# September 2013 Product Shipping Configuration Change Notice

## Engineering Advisory 88981

This engineering advisory provides details about shipping configuration changes planned for September 2013 to Polycom® Unified Communication (UC) software on Polycom® VVX® 600 business media phones. This notice is up to date as of September 2013. This notice is updated as new information becomes available.

**Figure 1: VVX 600 Console Label and Revision Code**

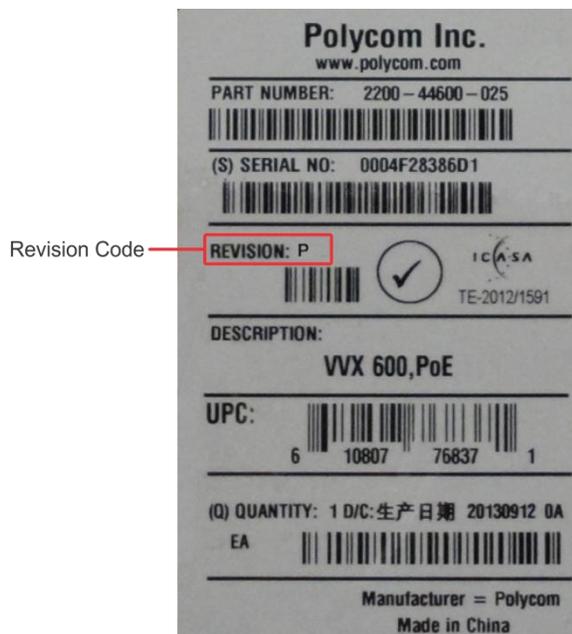
You can confirm that your VVX 600 phone includes the new touchscreen by viewing the revision code listed on the rear of the phone and on the shipping boxes, as shown below. This notice is updated to reflect the actual revision codes as information becomes available.

<i>Product</i>	<i>Console Part Number</i>	<i>Revision Code</i>
VVX 600 with new touchscreen	2201-44600-001	P
